CITY PLANNING COMMISSION

- APPLICATION:
1. Environmental Determination
 2. Lot Line Adjustment to merge two parcels into one 0.4± acre site for parking lot development
 3. Variance to waive six foot solid masonry wall on east property line (Section C-5)
 4. Special Permit to allow a parking lot in the Garden Apartment-Review (R-2A-R) zone (Section 2-B-28)

LOCATION: 1927 and 1929 Wentworth Avenue

PROPOSAL: The applicant is requesting the necessary entitlements to develop a parking lot in a residential zone to accommodate overflow parking during peak hours and provide employee parking for Raley's Market.

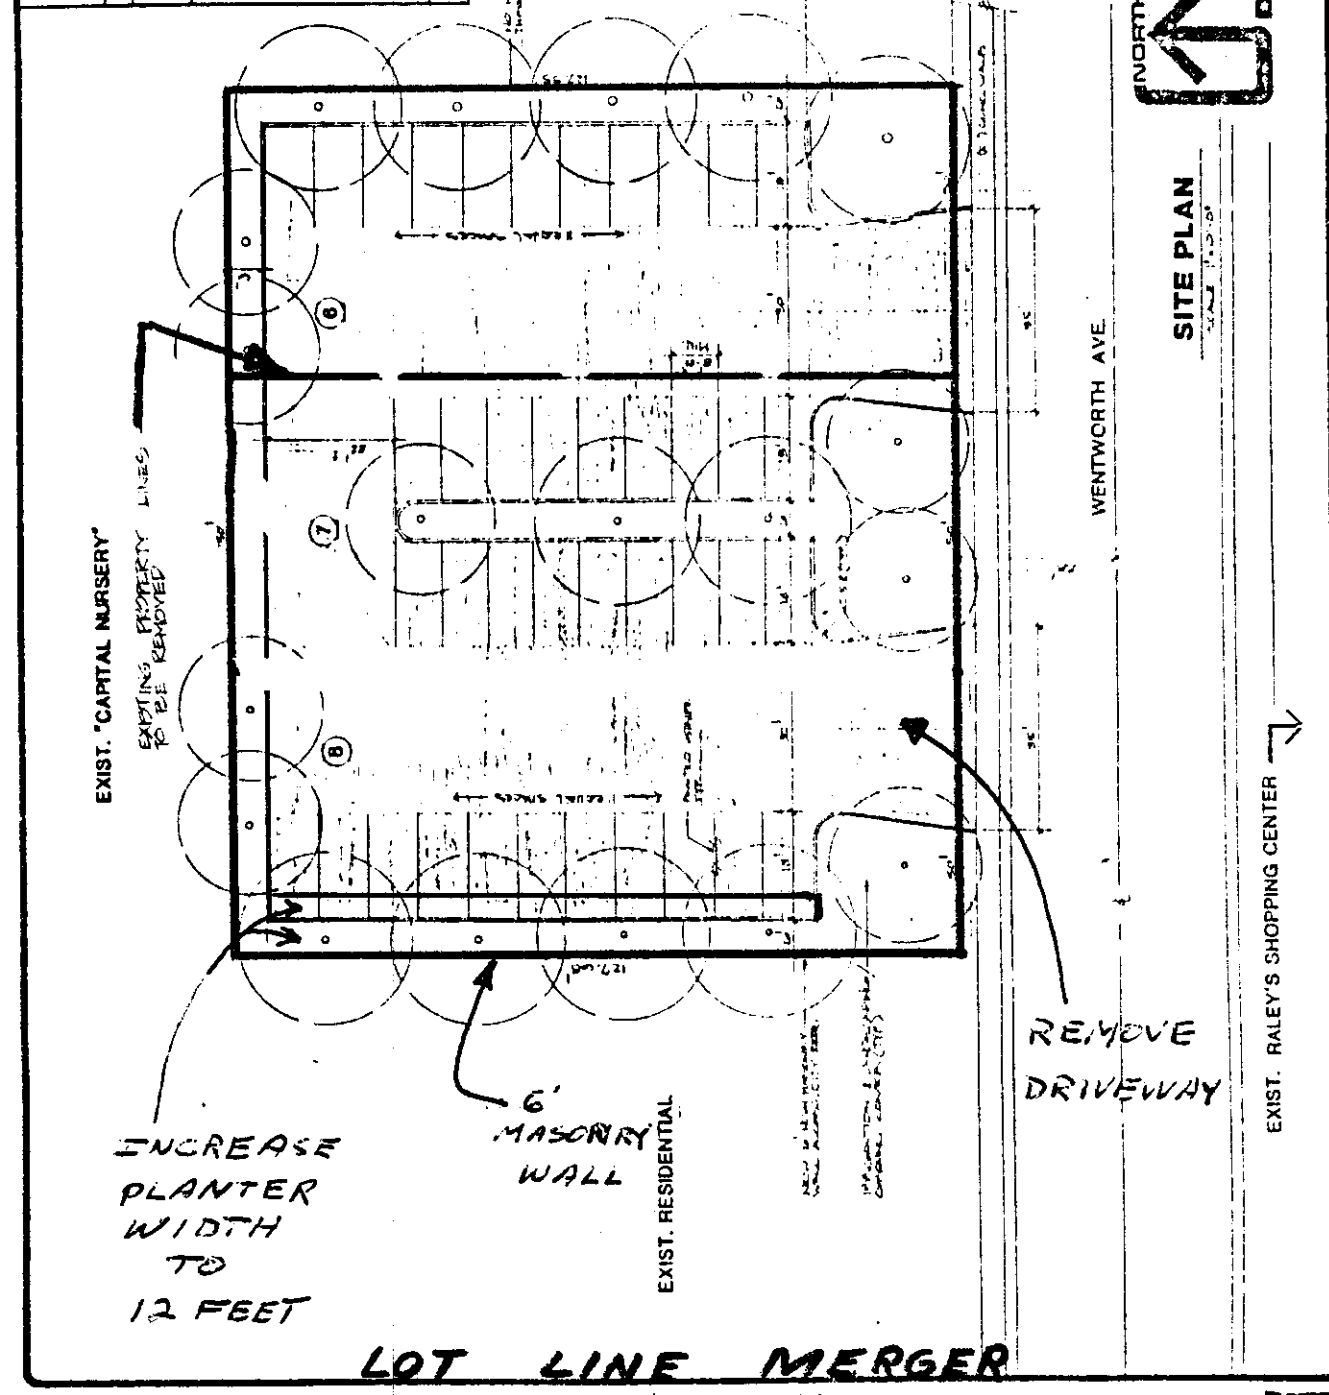
7. Staff has a concern regarding the location of the driveway near the single family residence. Staff suggests the westerly driveway be eliminated and replaced with landscaping. This will locate the parking ingress/egress farther away from the residential area and additional planting will provide a better transition between the residential and parking lot uses (see exhibit C).

8. To increase the buffer along the westerly property line, the six foot planting strip indicated on the site plan should be increased to 12 feet in width. This can be attained by reducing the parking stall depth from 18 feet to 16 feet and reducing the maneuvering space from 30 feet to 26 feet. This planting strip should be heavily landscaped with shrubs and trees (see exhibit C).

- c. The applicant shall eliminate the westerly driveway entrance and replace with landscaping. Revised plans shall be submitted to the City Traffic Engineer and Planning Director for review and approval prior to issuance of building permits.

- d. The applicant shall provide for a 12 foot wide planter strip along the westerly side of the property as indicated in exhibit C. This planter shall be heavily landscaped with shrubs, ground cover and trees.
